Howard Smith Wharves Redevelopment

This letter formally conveys the views of the Brisbane Central Business District Bicycle User Group (CBD BUG) on the essential characteristics of the proposed cycling corridor through the proposed Howard Smith Wharves Redevelopment.

FIGURE 1

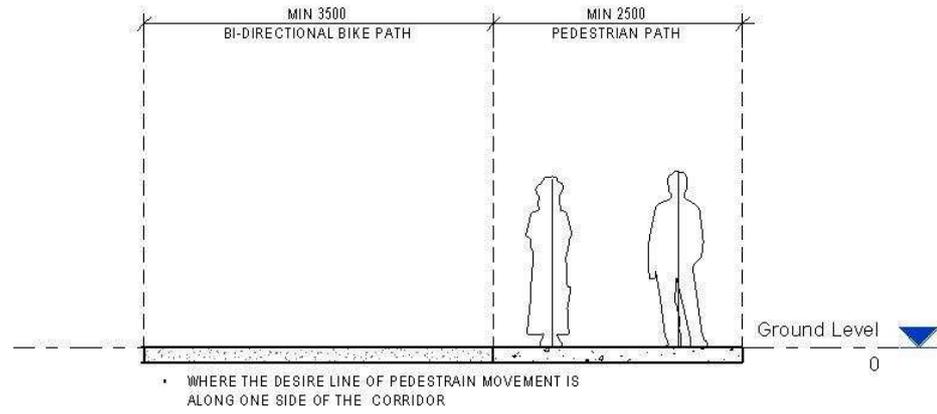
1. Segregation – As a shared facility the current path is less than ideal due to the potential for conflicts between pedestrians and cyclists, particularly during the peak travel periods. The CBD BUG welcomes the indication that the new facility will be segregated in a similar manner to the recently constructed Riverwalk. It is suggested that due to traffic volumes the minimum cycling path width of 3.5m be designed for. For further detail see Figure 1 and Figure 2
